ADDENDUM NO. 1

April 1, 2022

**PROJECT: Jerome Elementary School
Jerome School District
Jerome, Idaho**

A3.9
FLOOR/CEILING PLAN -
ADD ALTERNATE 1

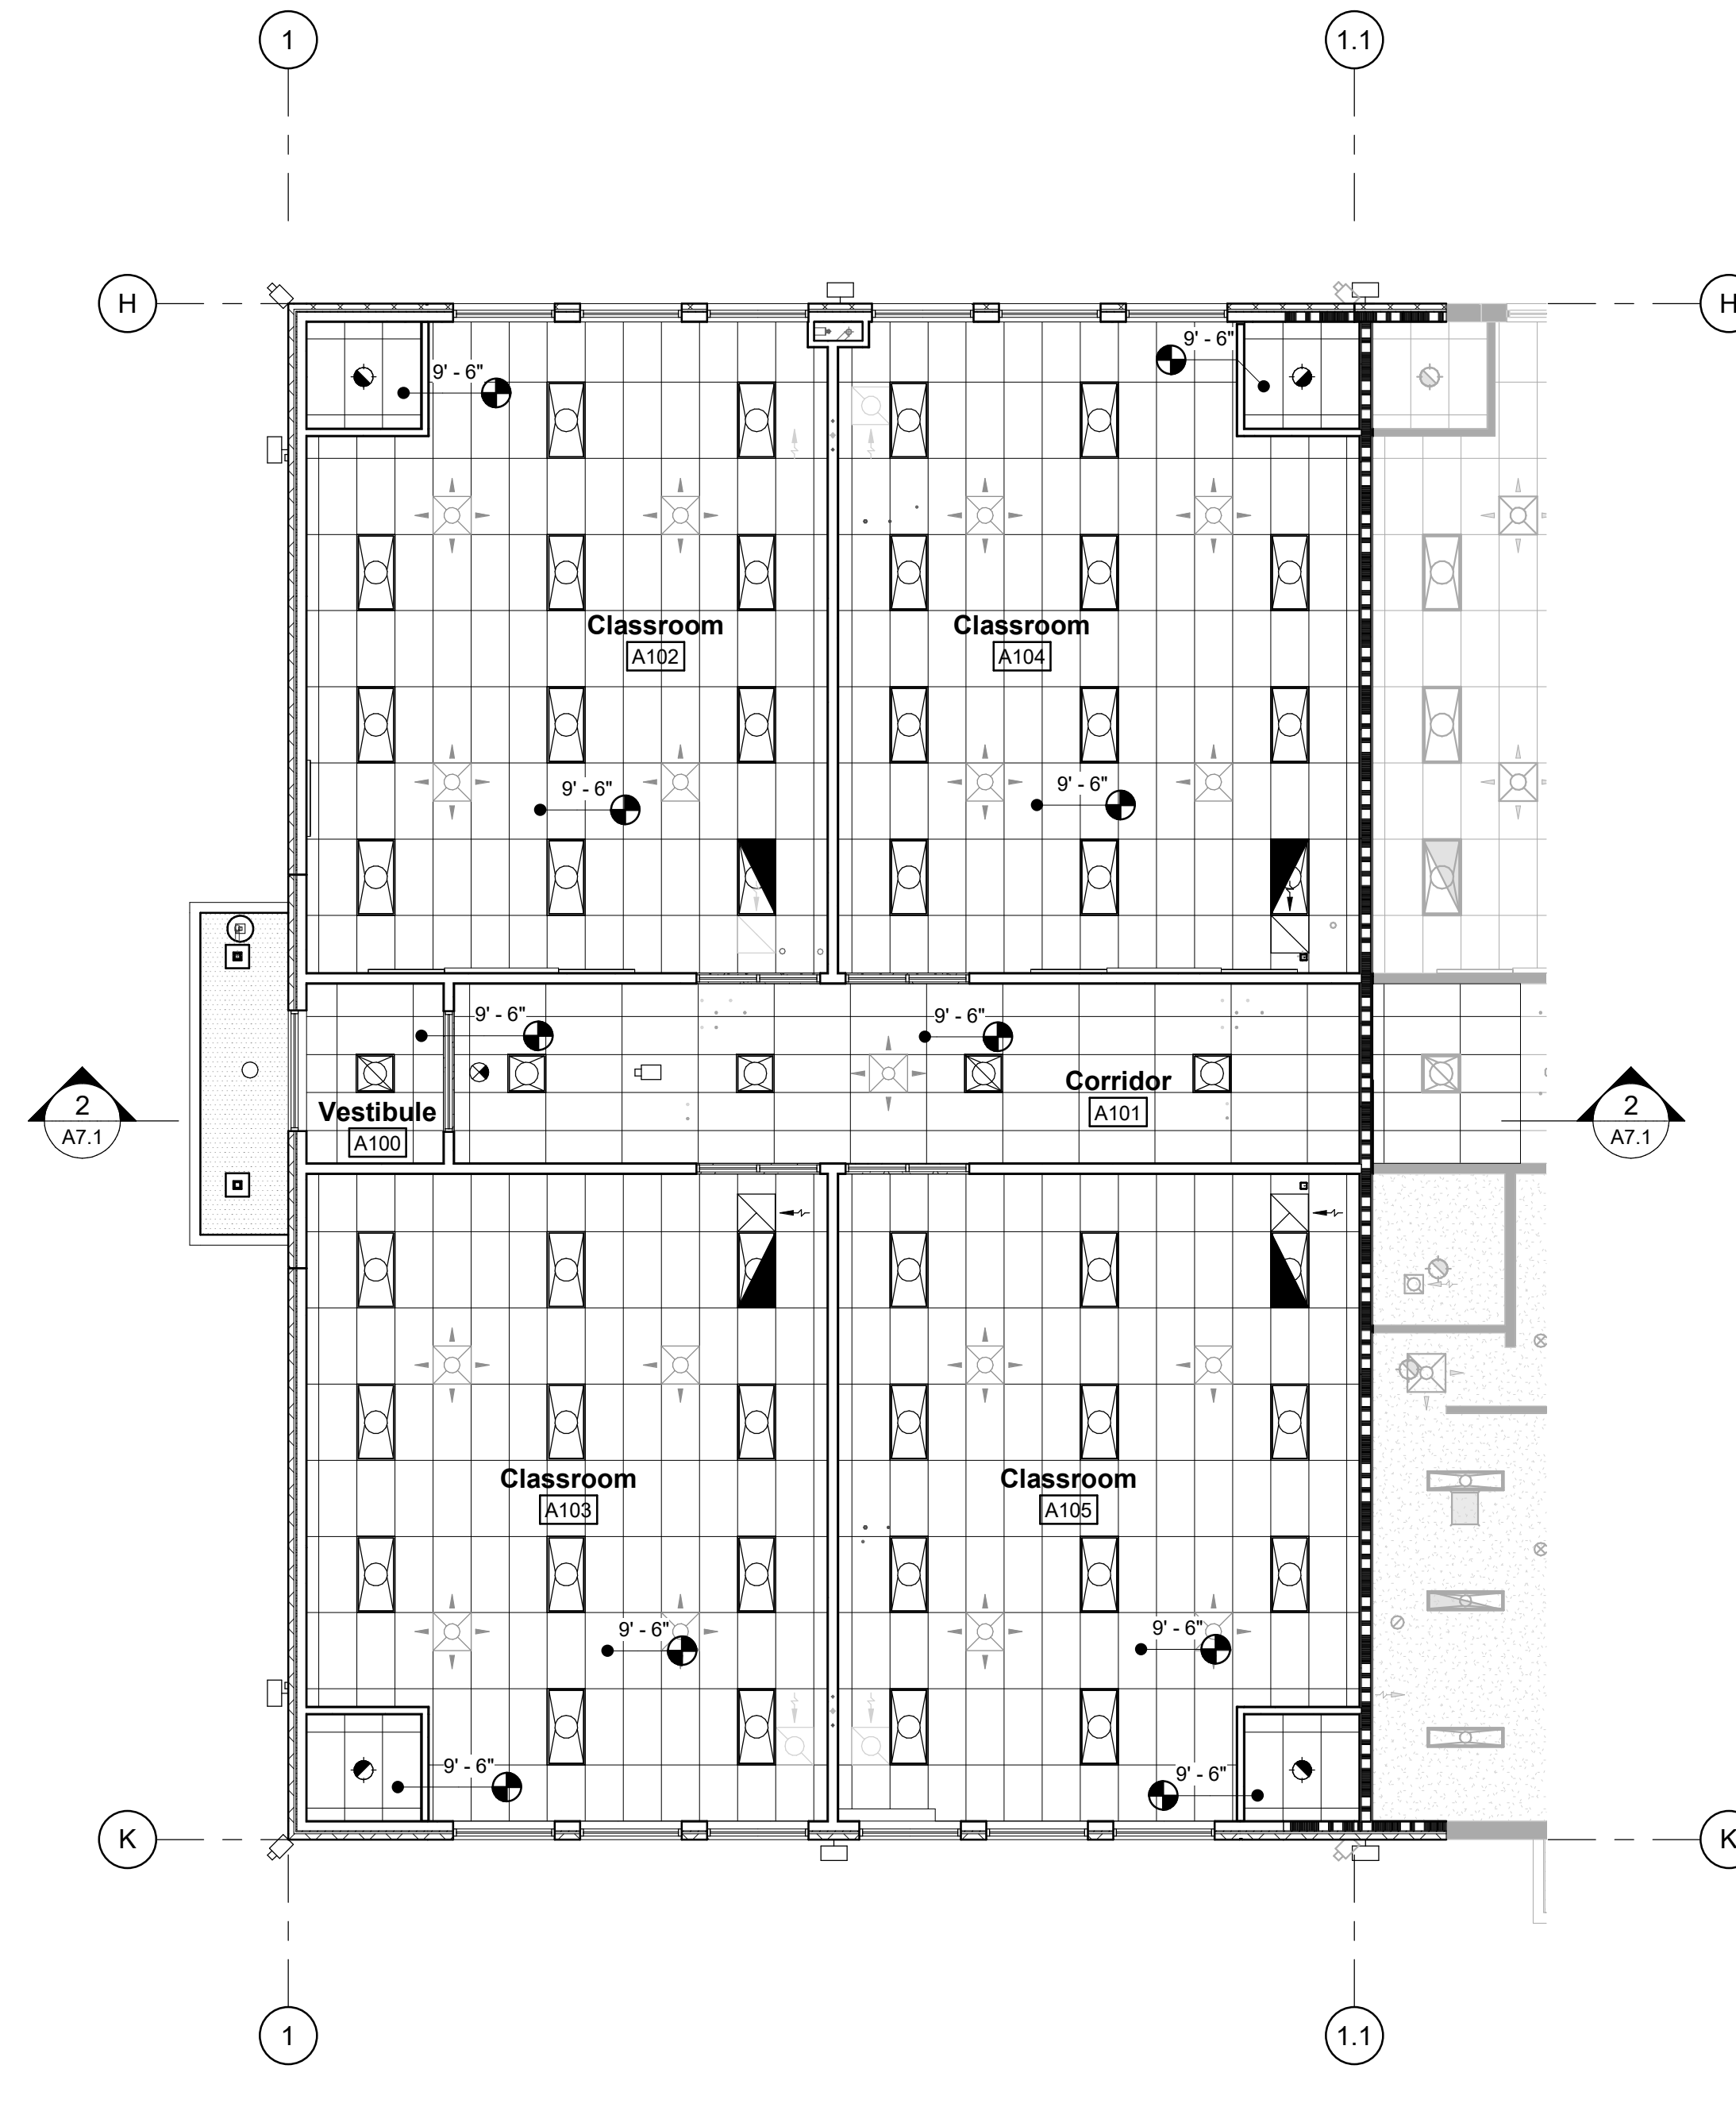
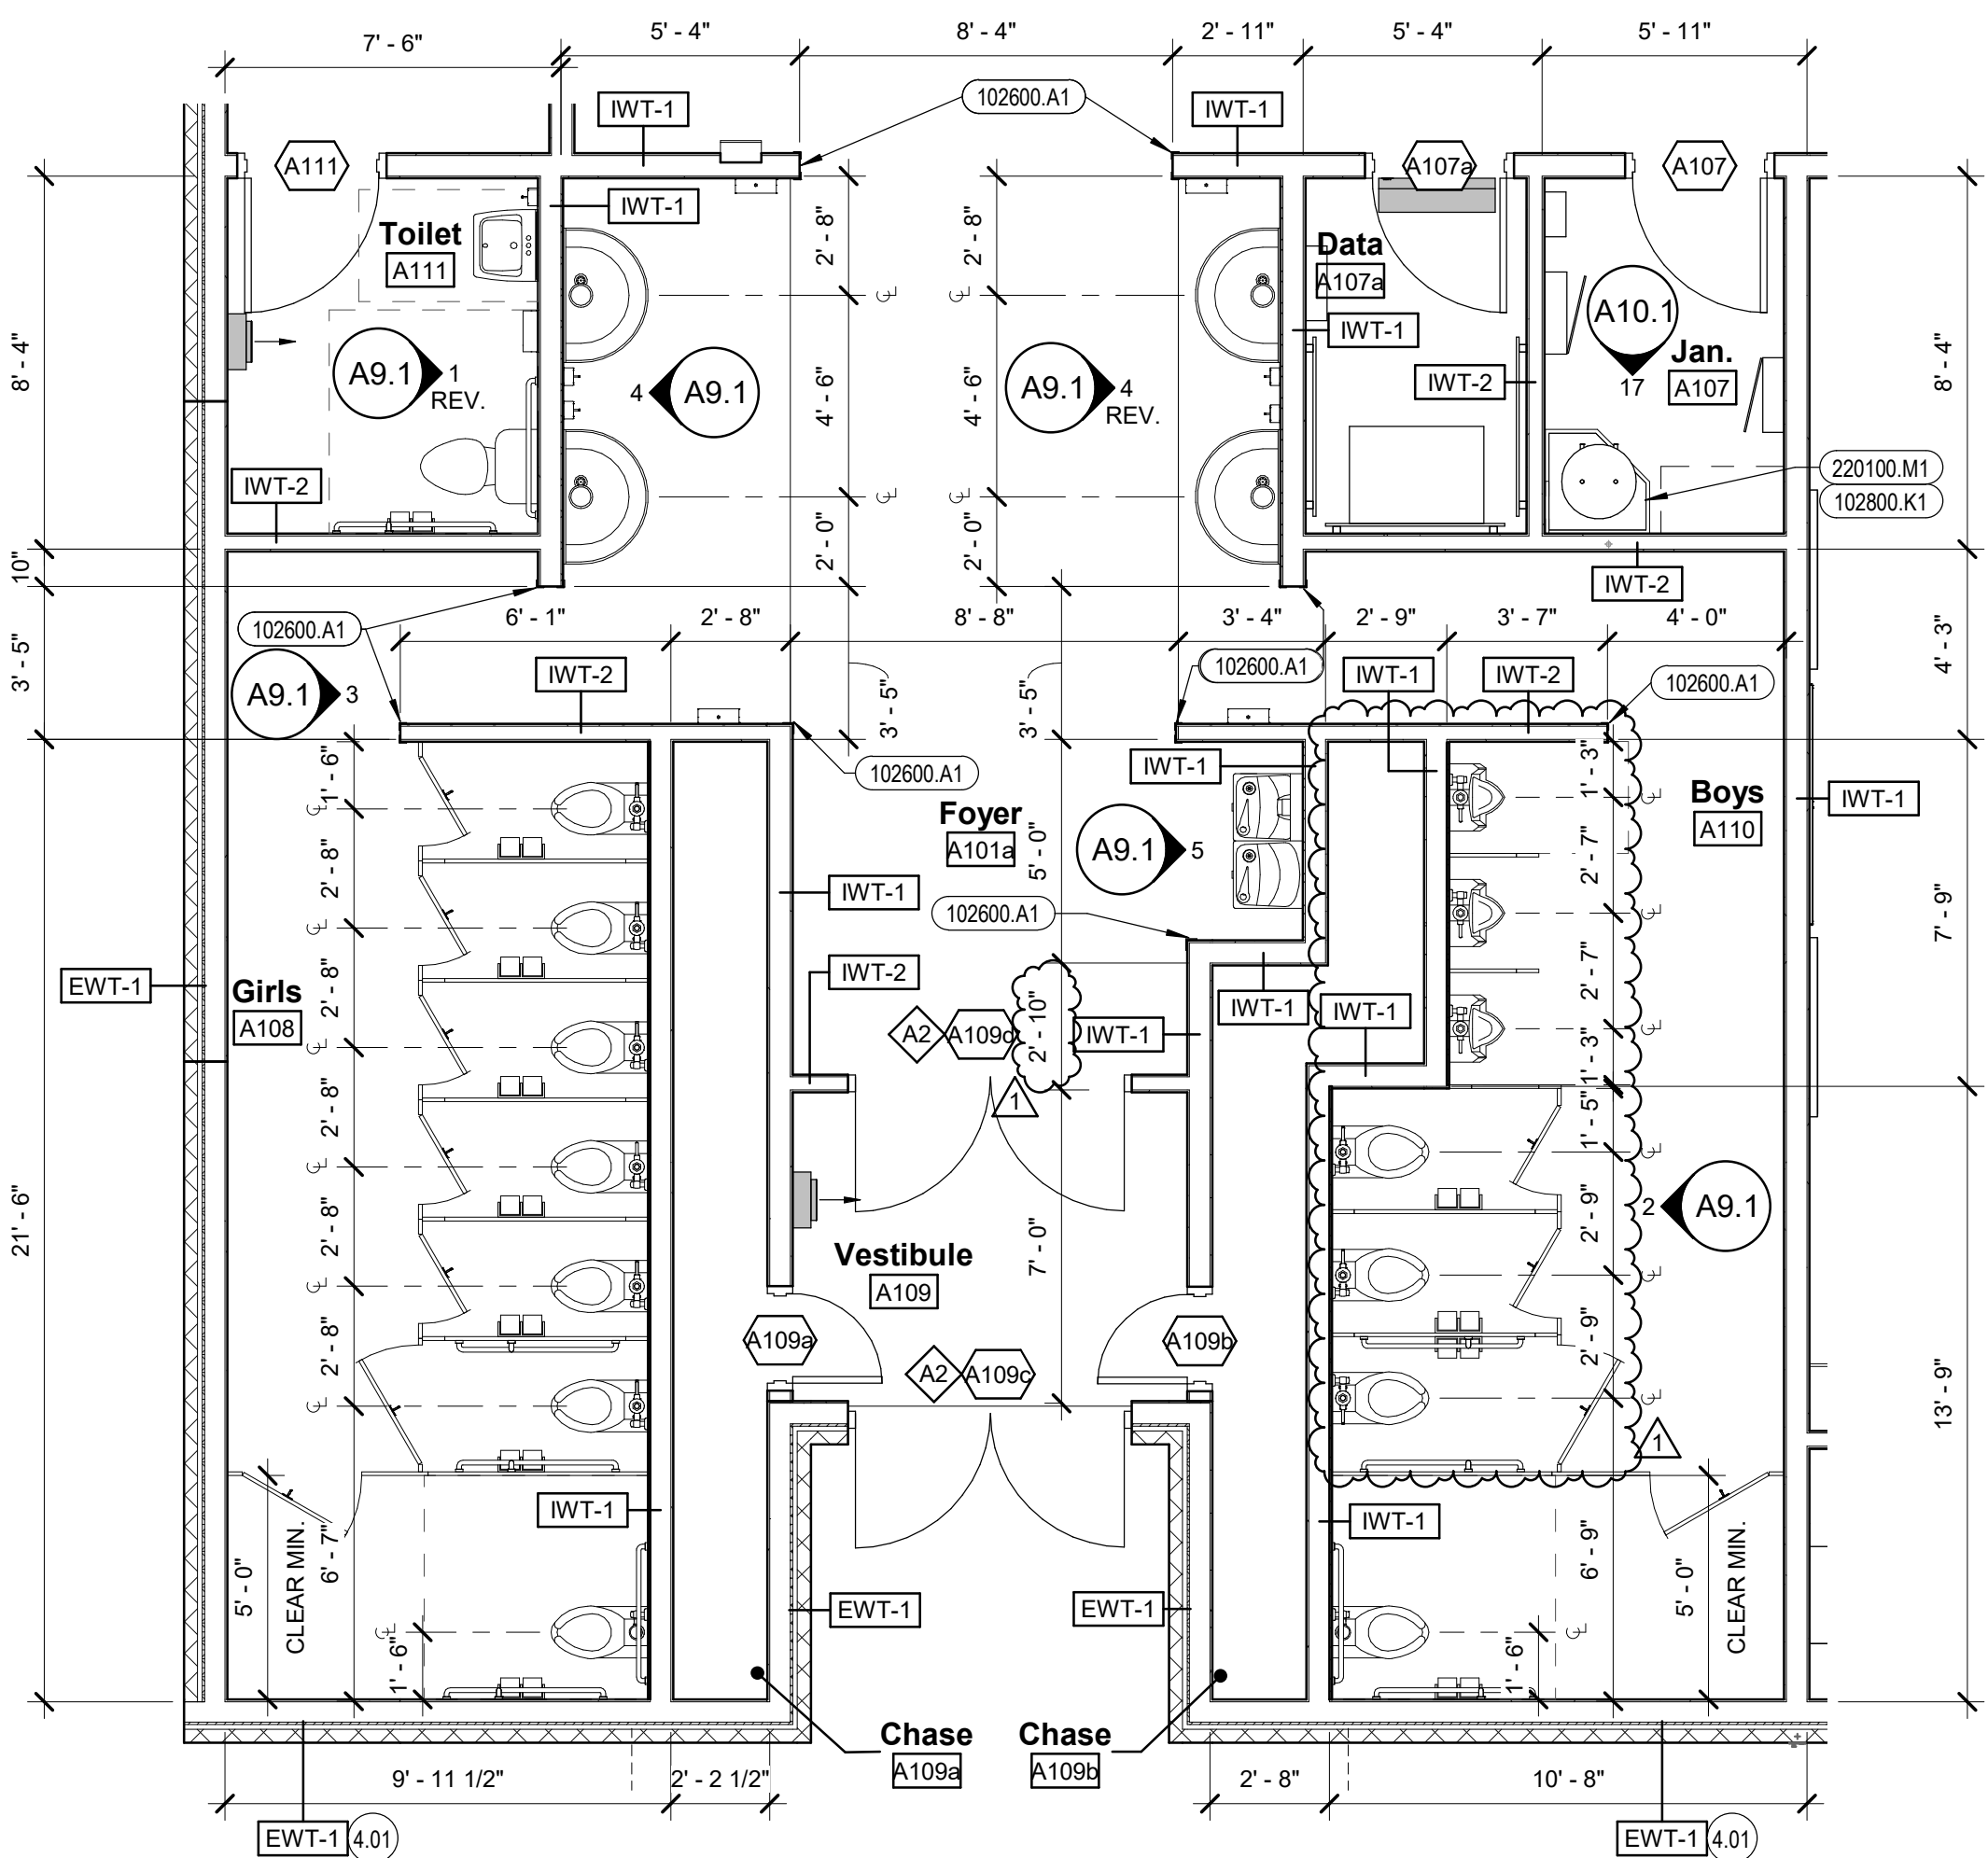
1. Provide new fire wall and 1 ½ hour rated door as shown per revised sheet A3.9, attached. Door shall be 8'-0"x7'-0", type A2, steel and painted. Frame shall be A1 steel, paint. Apply door remarks 7 and 10.
